33220A-02C

Supersedes:
33220A-02B

33220A 20 MHz Function/Arbitrary Waveform Generator

Encoder May Be Subject to Early Failure

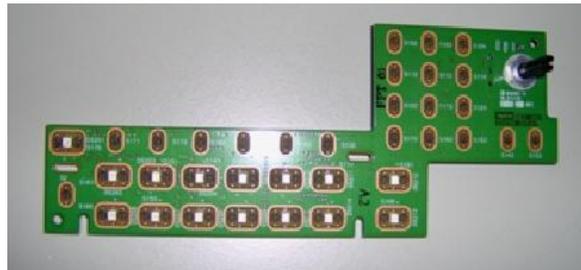
Mechanical encoders need to be replaced as they wear out with use, resulting in erratic knob behavior. Agilent has determined some 33220A encoders have been subject to early failure.

Customers with 33220A units displaying intermittent behavior of the knob should contact their local Agilent Service Center to arrange to have their instruments exchanged.

Customers have the option of repairing their own instruments by following the instructions on the subsequent pages. First order 33220-80002 front panel kit. The kit contains 3 parts:

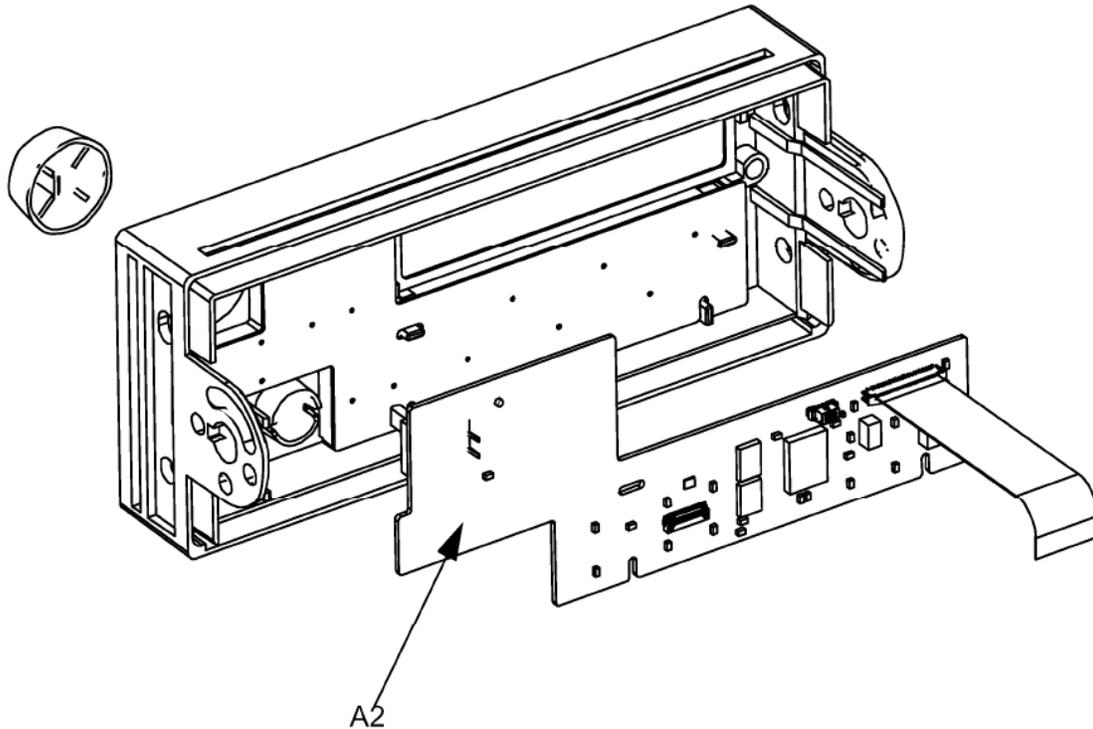
3. Pull to remove the knob. Lift out the keyboard PC board (A2 assembly).

4. Replace the following assemblies:
 - A2 front panel board, part number 33220-66512
 - Support plate, part number 33220-04112
